RAI 3.6.2.2.2-1a (High Voltage Insulators)

LRA 3.6.2.2.2 Degradation of Insulator Quality due to Presence of Any Salt Deposits and Surface Contamination, and Loss of Material due to Mechanical Wear

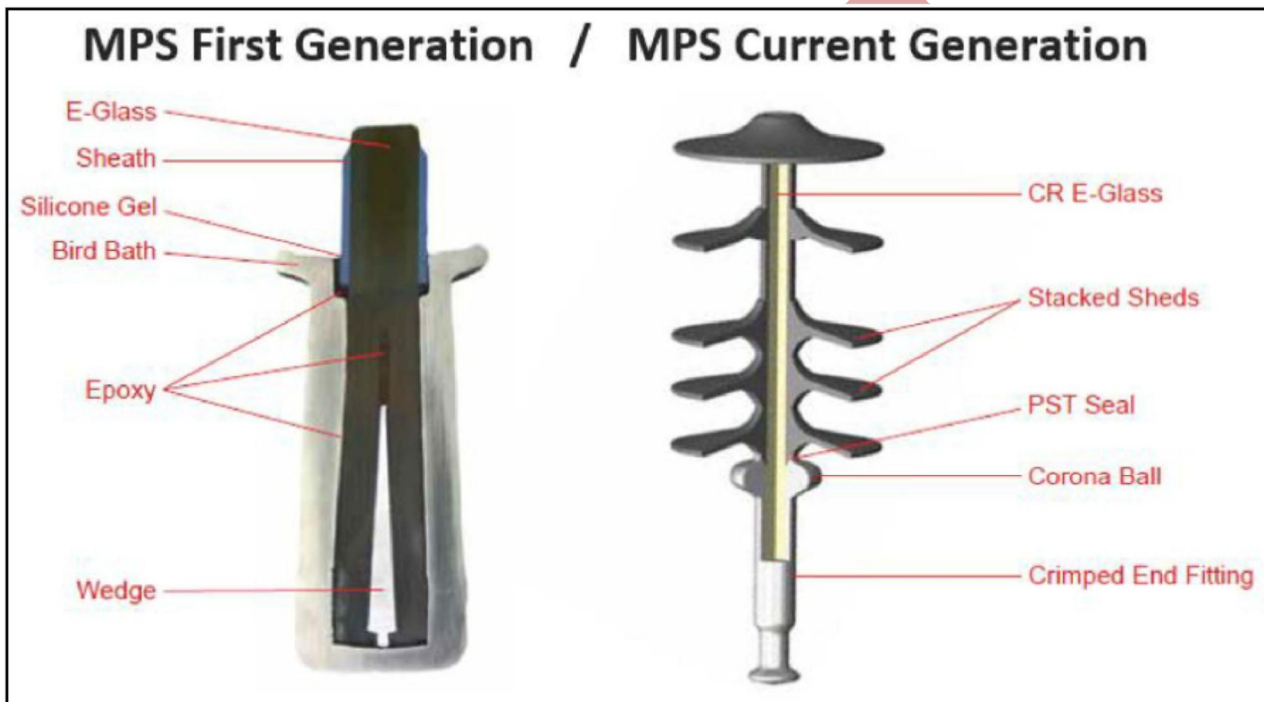
1. The material listed in the applicant's response to RAI 3.6.2.2.2-1 seems to have omitted certain material that are used in construction of the polymer insulators. According to vendor and EPRI literature, these include: epoxy, silicone gel, sealants, and ductile iron.

1. Explain why epoxy, silicone gel, sealants, and ductile iron are not listed in the response to RAI 3.6.2.2.2-1 as materials that are used in construction of polymer high-voltage insulators.

Information from the manufacturer (MacLean Power Systems or MPS) of the RBS polymer insulators does not discuss "ductile iron" for the corona ring or the end fittings, which are the only metal components on the insulators. The connection hardware does include ductile iron.

The response to RAI 3.6.2.2.2-1 stated, “The RBS polymer high-voltage insulators and connection hardware have the following materials: fiberglass, silicone rubber, aluminum and aluminum alloy, steel and steel alloys, galvanized metal (galvanized ductile iron, galvanized forged steel, steel hot dip galvanized).” Therefore, galvanized ductile iron is explicitly identified.

The RBS polymer high-voltage insulators are a recent generation of MPS polymer insulators that have been manufactured since 2007. The RBS polymer insulators do not use epoxy. The following figure shows the difference between the first generation of MPS polymer insulators and the generation of MPS polymer insulators that are used at RBS.

The MPS polymer insulators in service at RBS use a PST sealing system, which is a triple seal design. The triple seal or PST seal comprises the primary seal (P), the secondary seal (S), and the tertiary seal (T). The primary seal is a silicone rubber sheath compressed into the chamfer of the crimped end fitting. The secondary seal is RTV (room temperature vulcanizing) silicone applied to the rod, sheath, and end fitting interface. The tertiary seal is a final external RTV silicone seal applied to the sheath and end fitting interface. The RBS polymer insulators do not utilize silicone gel. The response to RAI 3.6.2.2.2-1 included silicone rubber, but did not explicitly identify RTV silicone as a type of silicone rubber. The silicone rubber material includes the RTV silicone that is part of the PST seal system. The RBS polymer insulators do not include silicone gel or sealants other than RTV silicone.
